Value Engineering Study Report – Final

I-69 Ohio River Crossing Project Evansville, IN and Henderson, KY

August 2, 2019

Idea Title	In lieu of bridge/fill, use prefabricated culvert (BEBO)
Function	Span Space

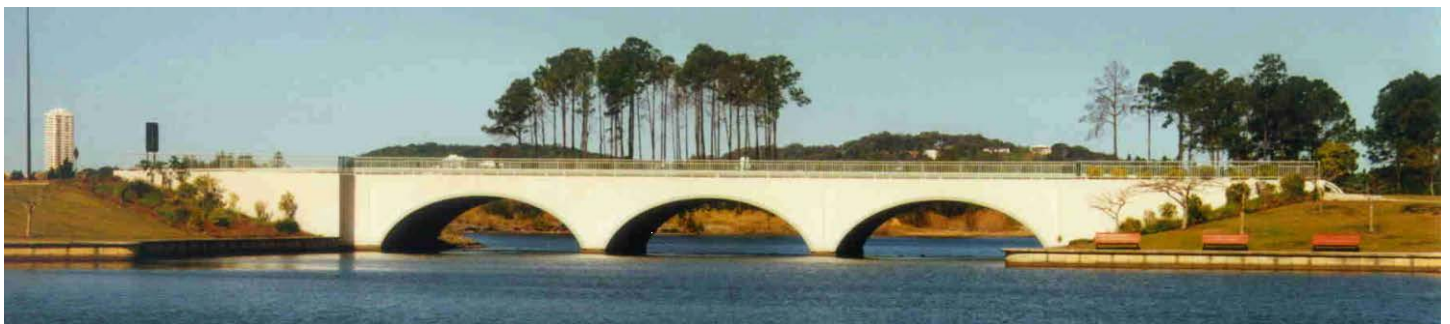
The alternative concept proposes to use buried type structures such as BEBO or multiplate arch type structures and replace the north approach bridges for I-69. This would replace the original fill section north of the river crossing around Station 4150+00 with an equal amount of foundation in the floodplain for BEBO structures.

Hydraulic impact and surge need to be further analyzed because of restricted flow, added friction and freeboard requirements.

This concept could completely replace the north I-69 approach over floodplain which is about 494,000 square feet of aerial structures. The original estimate assumed \$135 per square-foot for this area and BEBO structure

Idea Title	Use trench section in lieu of bridges in the floodplain
Function	Span Space

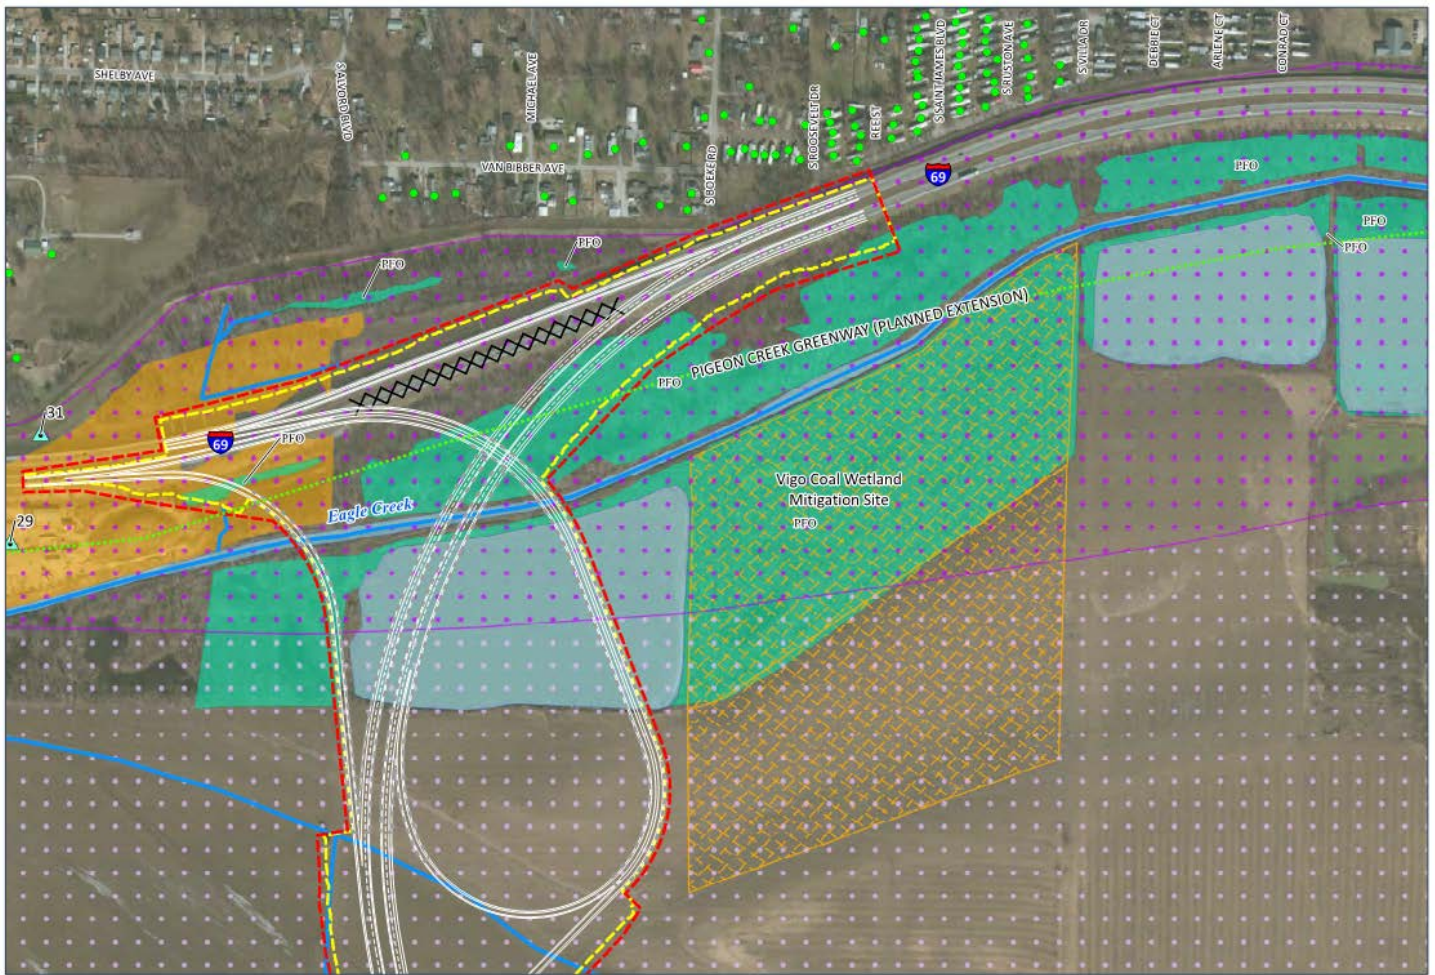
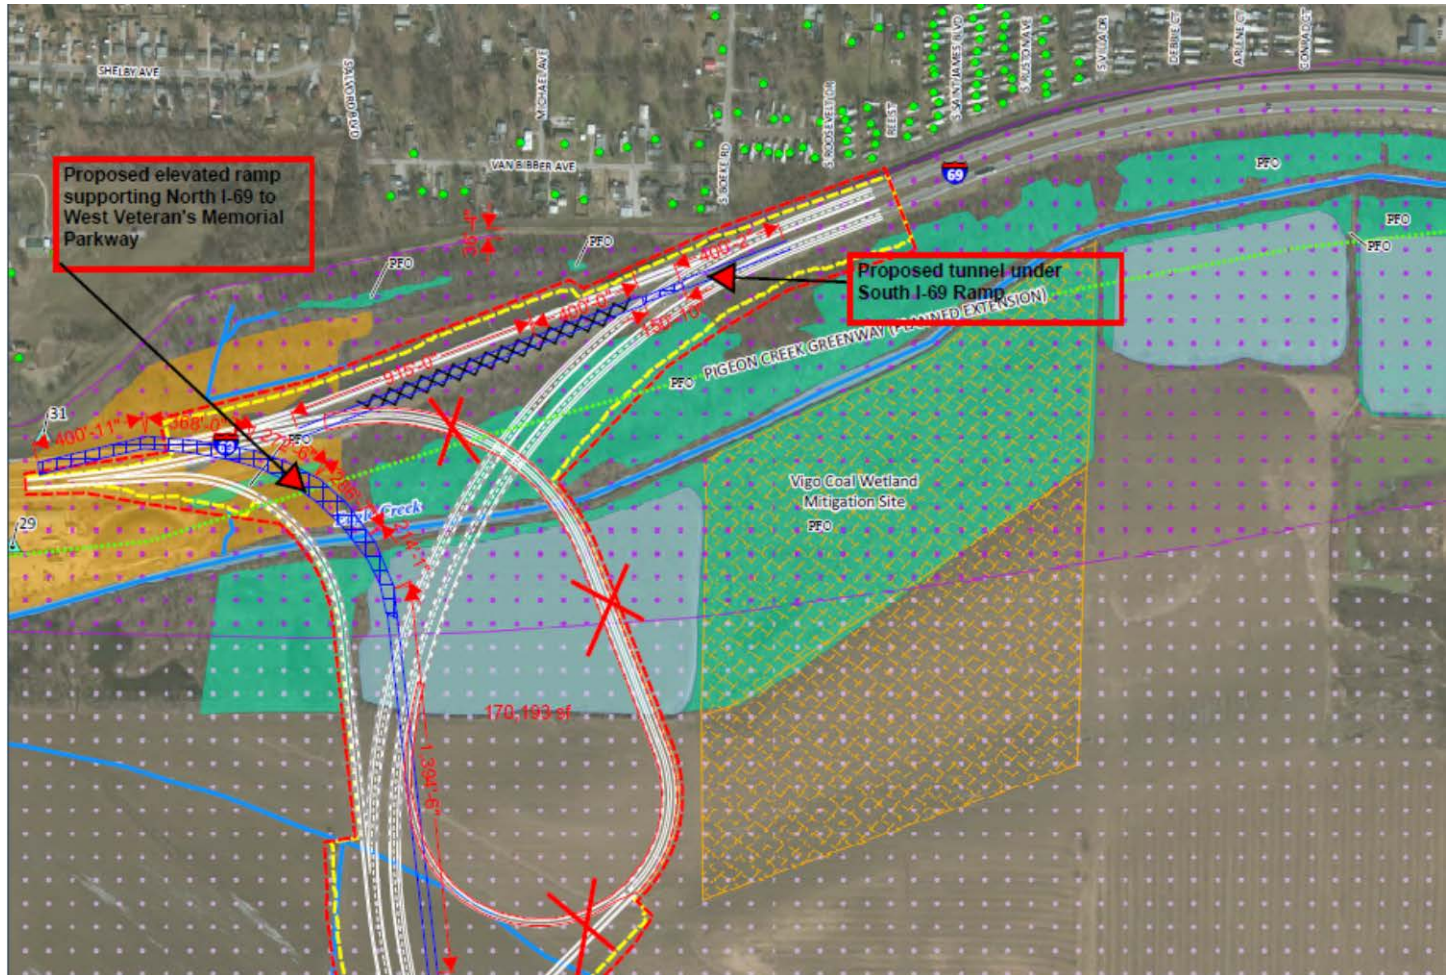
Depress the east bound lanes as the Parkway ties into I-69 North. The deepest point will result in a 150 LF tunnel section of the Parkway. This tunnel section allows the proposed I-69 South ramp to cross the Parkway at grade. The first modification allows for removal of the proposed elevated looping ramp system providing connectivity of the Parkway to I-69.

The second modification involves constructing a 3,000 LF elevated ramp connecting proposed North I-69 to West Veterans Memorial Parkway.

The combination of these two modifications allows for the removal of approximately 180,000 SF of bridge. Potential challenges in implementing this modification include:

- Dewatering and management of groundwater during construction
- Support of excavation
- Flood management of the finished tunnels
- Safety and monitoring systems for the finished tunnel
- Access to the work zone during construction
- Interstate regulations related to construction below flood level

Idea Title	In lieu of pier support islands, build roadway embankment on the north to shorten bridge
Function	Miscellaneous

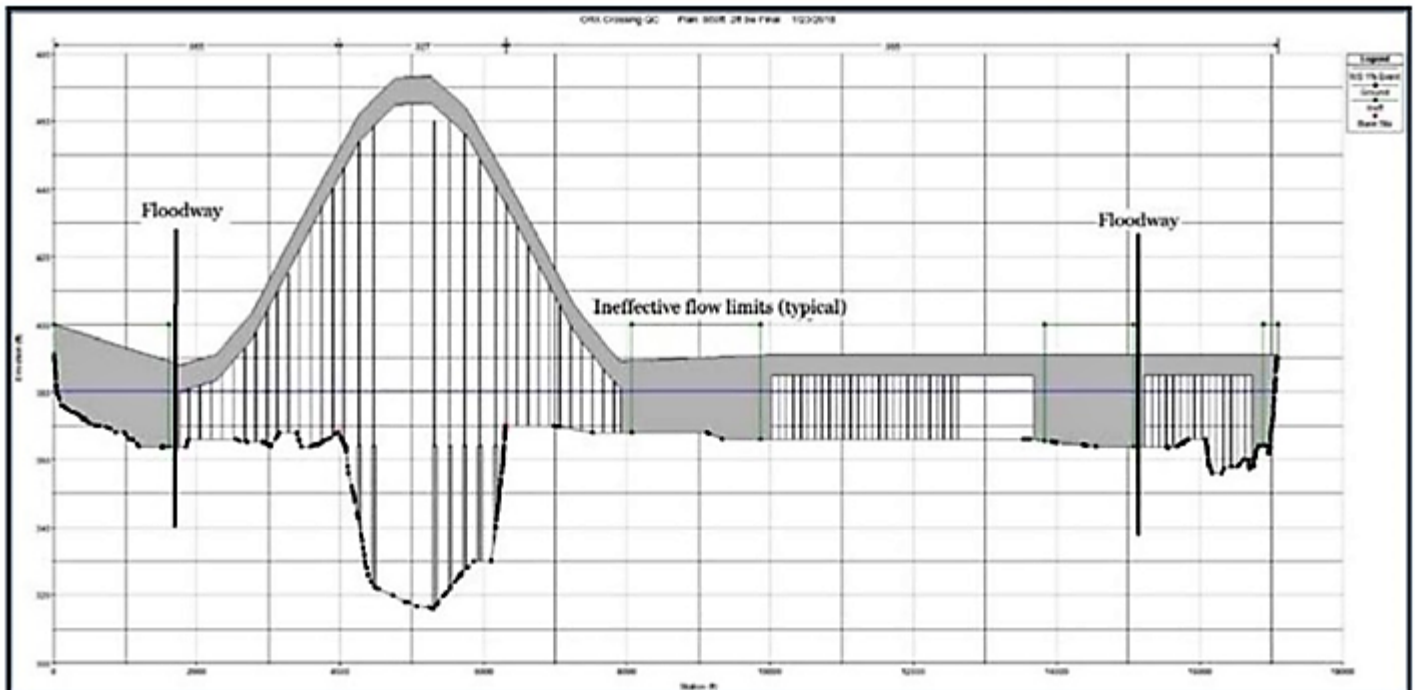
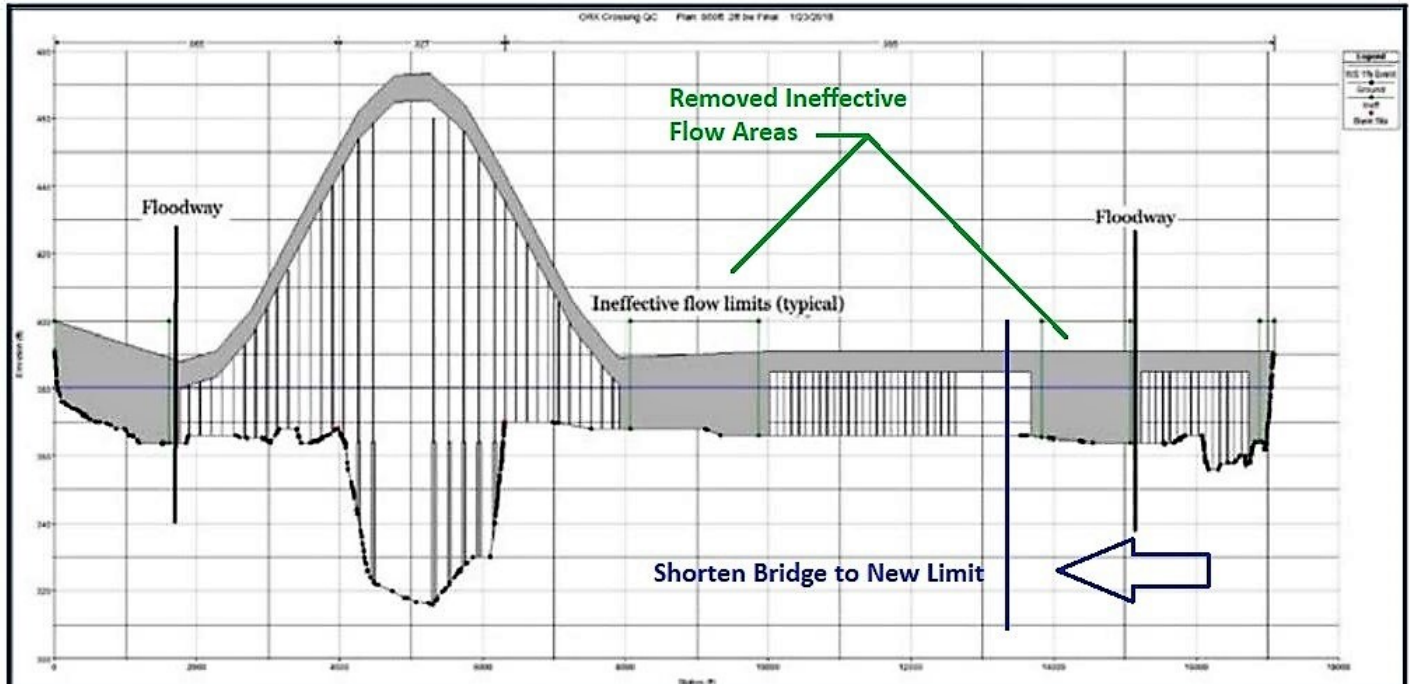
Instead of constructing these islands which remove flow area from the river cross section, remove that flow area from the north end and shorten the structure.

Permits from the U.S. Army Corps of Engineers would need to be modified if already obtained. If a Letter of Map Revision (LOMR) has been completed, it would need to be re-done.
